The Prospect Highway upgrade

Submissions Report

Roads and Maritime Services

Submissions report
October 2014

Figure 2-2 Roger Place access

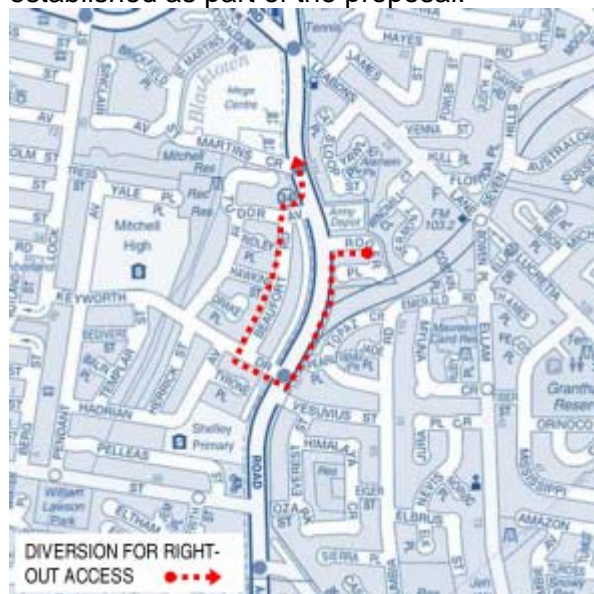
- The upgrade should include a right turn out of Roger Place
- The proposed access route that would replace the existing right turn out of Roger Place would be illegal for heavy vehicles
- Increased local traffic along Keyworth Drive, Tudor Avenue and Beaufort Road would increase the time taken to travel along the detour route
- A median break should be provided to facilitate a two stage right turn out of Roger Place
- The right turn out of Roger Place should be facilitated via a roundabout or traffic lights.
- A time restricted right turn out should be considered

The right turn movement out of Roger Place was reassessed following the display of the REF. Figure 6-2 of the REF shows the existing hourly traffic volumes along Prospect Highway just south of Roger Place. An intersection assessment was carried out to review the ability of traffic in Roger Place to safely turn northbound onto Prospect Highway. The results indicated this movement could not be safely completed for the majority of the week.

Hourly traffic volumes along Prospect Highway confirm there would be limited safe opportunities for vehicles to turn right out of Roger Place across both carriageways. This difficulty is compounded by the increased number of lanes on Prospect Highway. Figure 2-2 shows the proposed Roger Place access that would be established as part of the proposal.

A time restricted right turn movement out of Roger Place was considered as a compromise, however the safety risks associated with the operation of this restriction

could not be effectively managed. Analysis of the existing time restricted right turn movements into Vesuvius Street found four of the five crashes at this intersection were during restricted time periods. The crashes at Vesuvius Street show time restricted right turn movements cannot be effectively managed and they are often ignored. As a result the intended traffic flow and safety benefits of the time restriction are not achieved.

For these reasons, the median would not be modified to permit a right turn out from Roger Place as part of this proposal.

Figure 2-3 Potential noise barrier 1

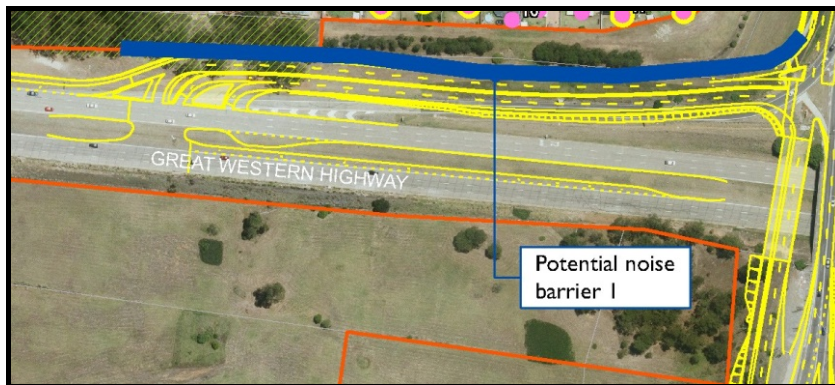
way link road, but questioned the nature of the proposed noise mitigation treatment along the two way link road.

The proposed noise barriers are discussed in Section 6.2.3 of the REF and are included in Figure 2-3 to Figure 2-6 of this report. Roads and Maritime acknowledges support for these potential noise barriers and their locations. The exact location, extent and size of any potential noise barriers would be determined following a noise barrier assessment during the detailed design stage. Affected residents would be kept informed during the detailed design process.
